Land Adjacent to Windhover Roundabout
Bursledon

Response to Highway Authority Comments

Wates Developments Ltd

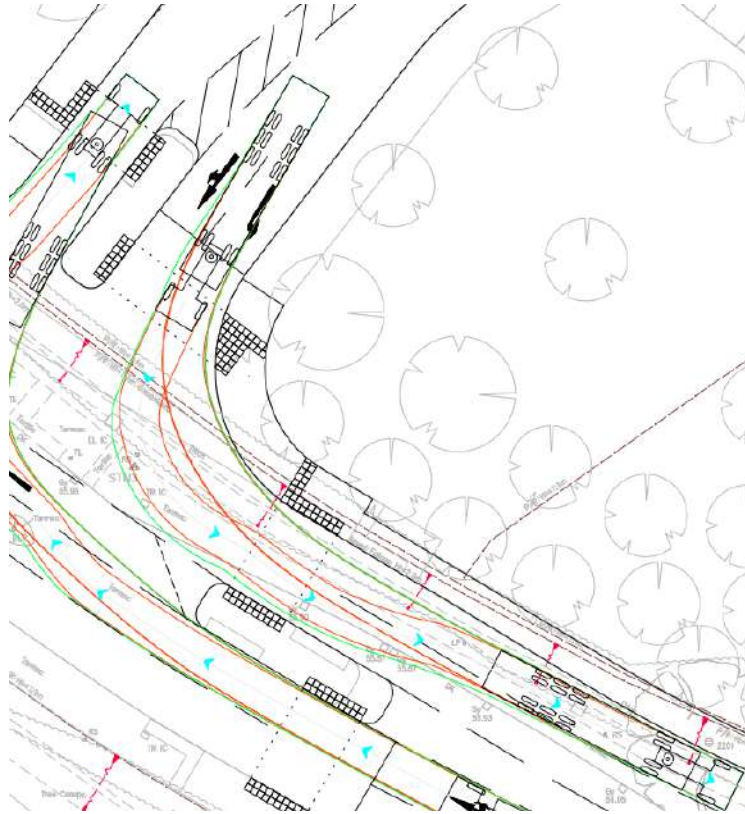
Drawing 1803014-TK01 C illustrates a max legal length HGV ingressing and egressing the junction. The right turn manoeuvre into the site is very tight and would require a HGV to position itself perfectly and not continue in the ahead lane, blocking the junction. There is a high probability that the HGV will partially obstruct the ahead traffic in the westbound offside lane. To avoid ahead drivers attempting to steer around the back of the HGV the right turning storage area within the junction would need to be wider to ensure it can fully accommodate an HGV.

- 2.9 Swept path analysis has been undertaken at 10 miles per hour in accordance with HCC guidance. The swept path analysis has been updated to reflect the updated internal site layout and is included at **Appendix D**.

Bursledon Road Site Access

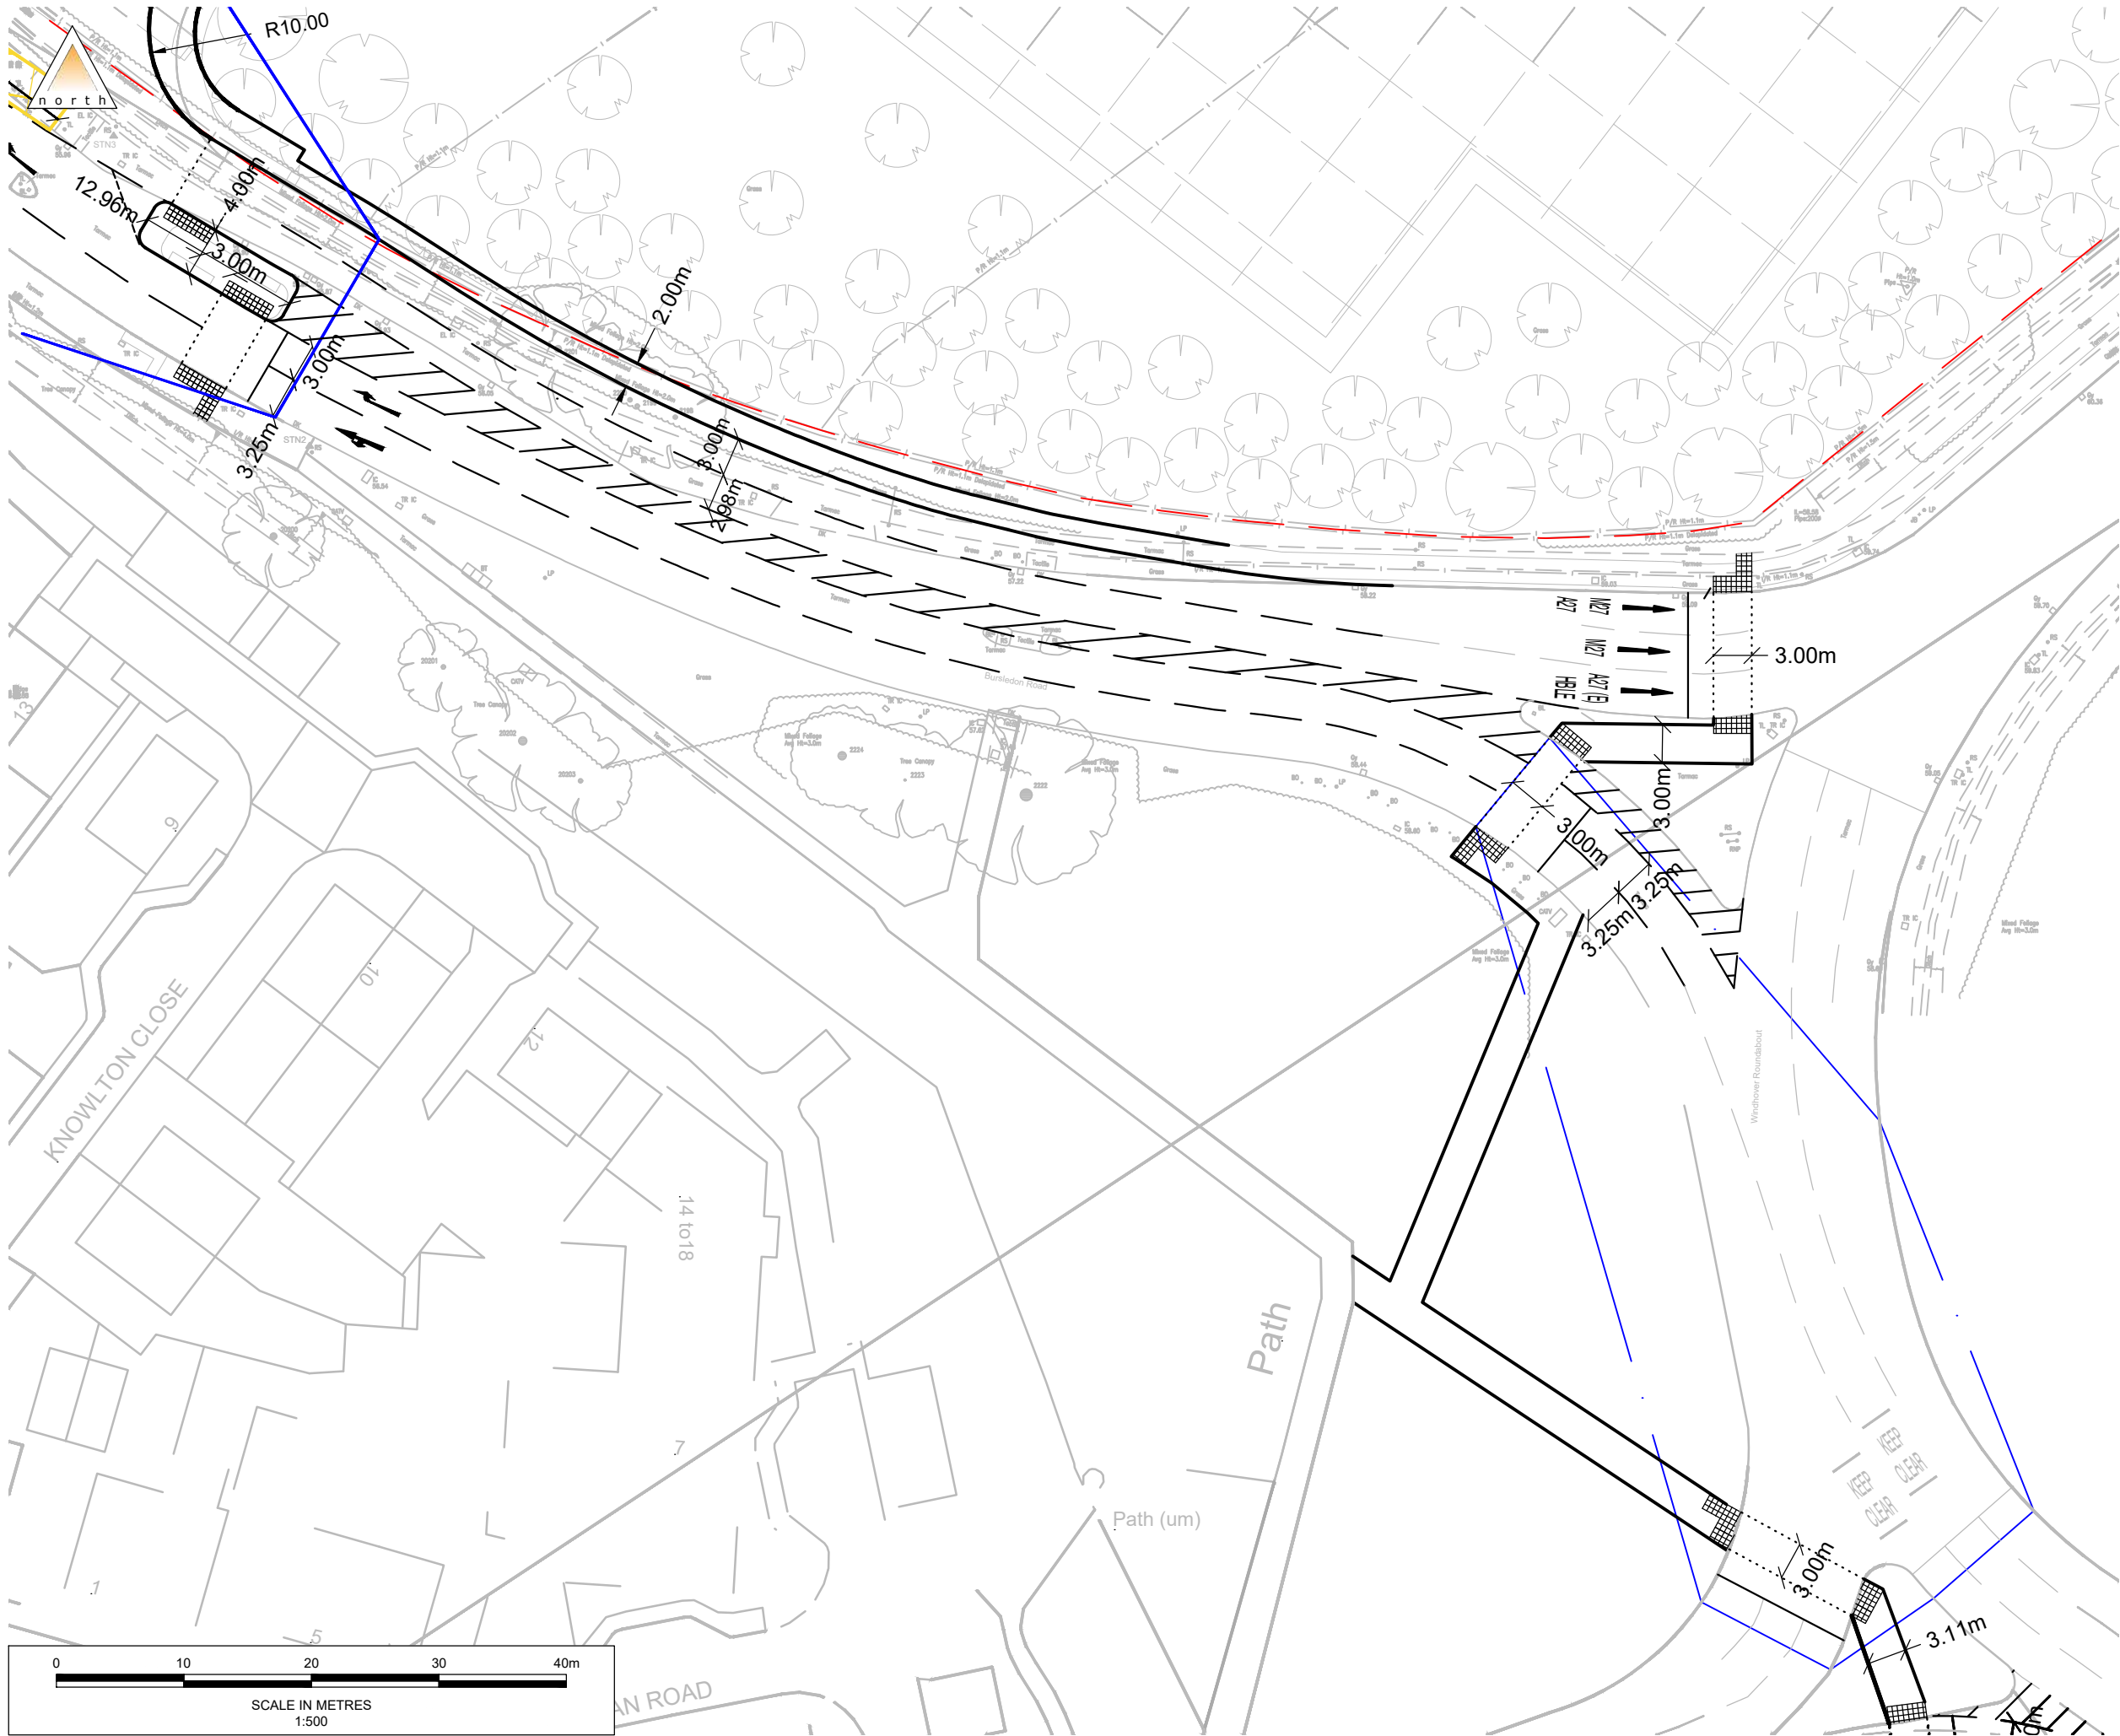
The submitted drawings show a red dashed line which is assumed to be represent the highway boundary. There are also banking 'tadpoles' which are also shown in red. Further clarity is requested on these points.

The merge on the westbound Bursledon Road exit is very short and does not provide clear priorities. Geometrically the generally slower moving nearside lane traffic would need to merge into the faster moving offside lane traffic. As shown, it is unacceptable and would need to be significantly improved. This would require the merge distance to be extended and for the offside lane to clearly merge into the nearside lane. Furthermore, waiting eastbound right-turning traffic is directly next to the merge, with no separation or kerb, which could result in head on conflict. Centre hatching would also be required in this area to separate the opposing traffic.

The existing junction road markings have not been shown. These should be illustrated to provide context for the proposals. It is also unclear why the existing yellow box markings have been removed from the proposed junction.

- 2.5 Noted, these were blocks illustrating a bank within the topographical survey. These blocks have been amended and recoloured within the CAD drawing of the accesses, within the updated access drawings included at **Appendix C**.

- 2.10 An additional island has been provided on the eastbound Bursledon Road arm to allow for the provision of a signal head to separate out the right turning phases into a separate stage as requested within the HCC response.
- 2.11 As a result of this, the ahead lanes for westbound traffic has been reduced to one lane at the junction and therefore no lane drop is provided on the updated layout. This is illustrated on the updated access plans at **Appendix C**.

- 2.12 Noted, the existing yellow box junction elements have been incorporated into the updated layout included at **Appendix C**.

West End Road Site Access

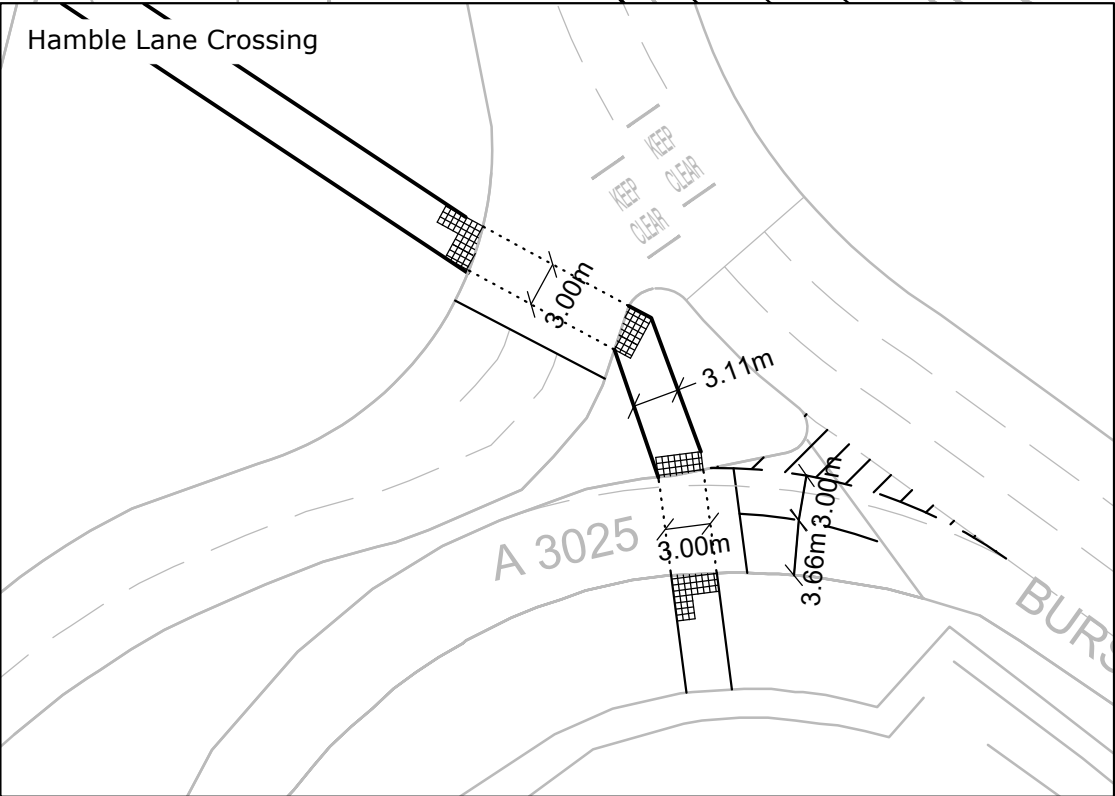
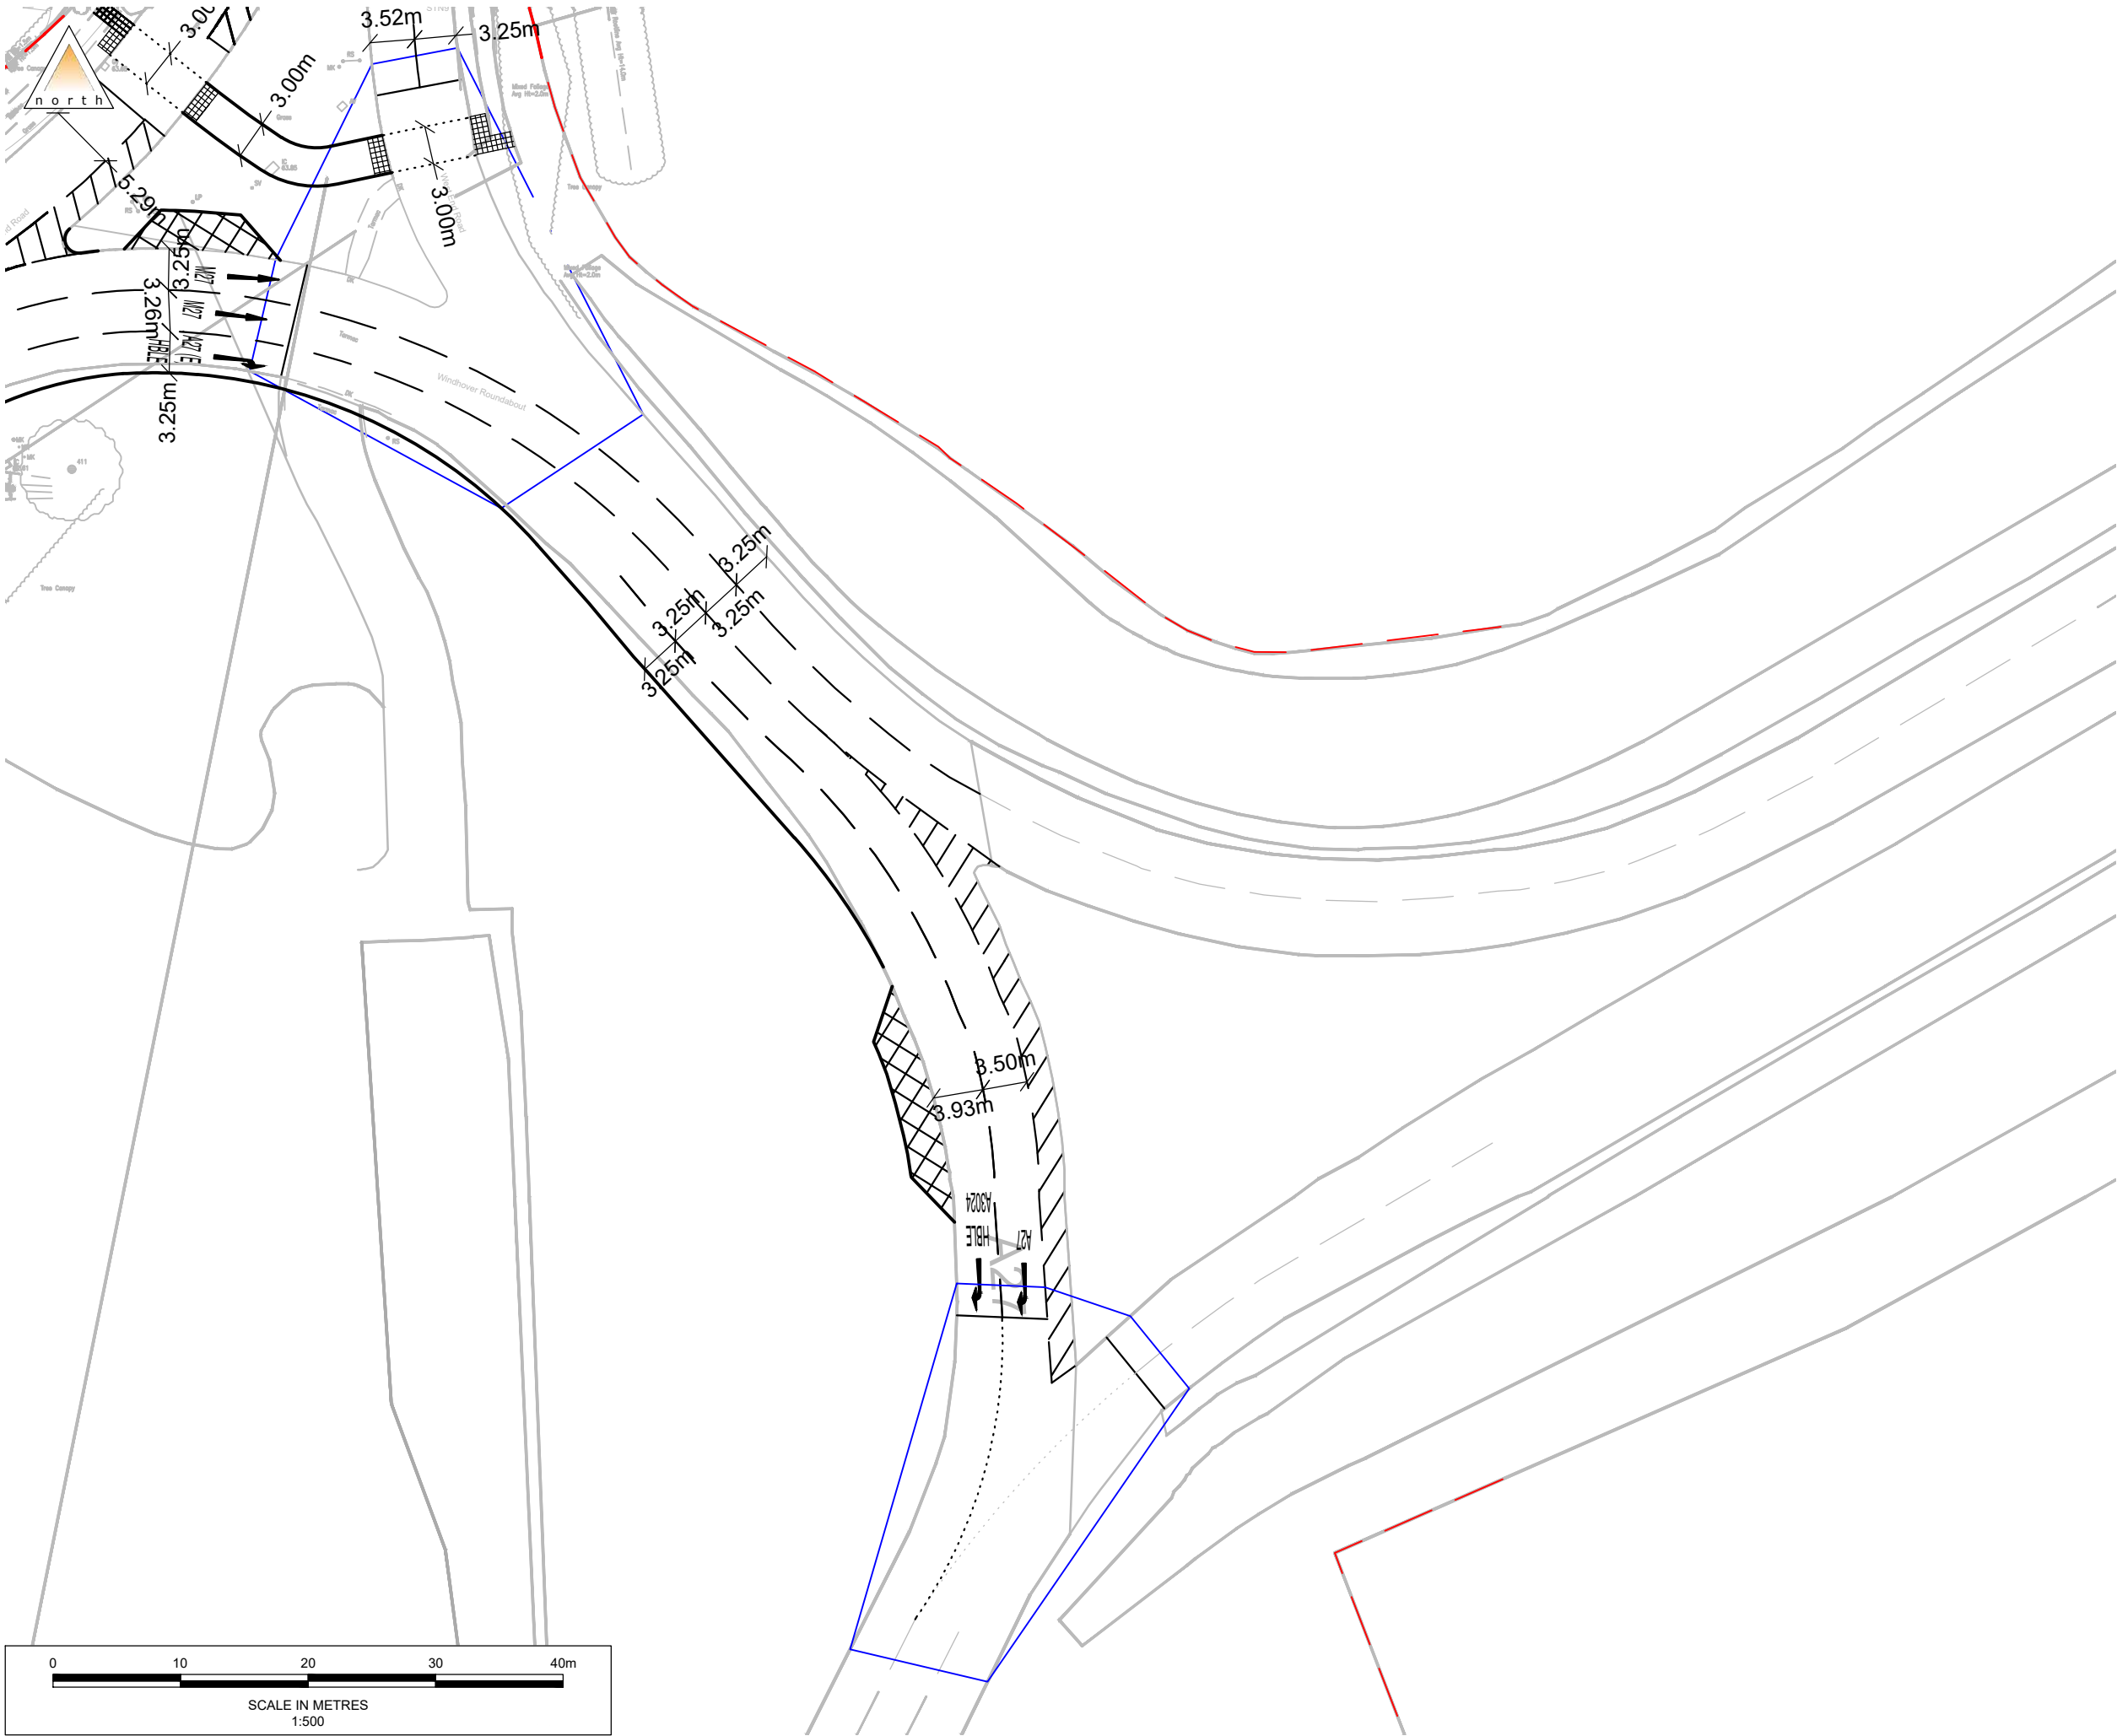
The submitted drawings show a red dashed line which is assumed to be represent the highway boundary. There are also banking 'tadpoles' which are also shown in red, and further clarity is required on these points.

Junction visibility splays are shown as 2.4m x 120m in each direction, and a 2.4m x 90m visibility splay has also been shown. While it accepted that the 120m visibility splay to the south is not appropriate given the amount of land take necessary, the revised 90m visibility splays are also considered to be unacceptable at this time. In accordance with HCC Technical Guidance Note 3, Stopping Sight Distances (SSD) and visibility splays must be based on surveyed vehicle speeds. On this basis, two speed surveys should be undertaken in order to calculate the required junction visibility splays.

The submitted HGV tracking plans shows that a HGV cannot access the site without crossing the site access centreline. Similarly, the exit manoeuvres show the HGV swept path taking up the full West End Road carriageway width. With two examples shown below:

- 2.28 The updated access arrangement drawings, included at **Appendix C**, include geometry information.
- "The submitted drawings show a red dashed line which is assumed to be represent the highway boundary. There are also banking 'tadpoles' which are also shown in red, and further clarity is required on these points."*

- 2.38 This junction has been subject to a Junction 9 (PICADY) assessment, as requested later within the HCC response, alongside being subject to a Stage 1 Road Safety Audit.
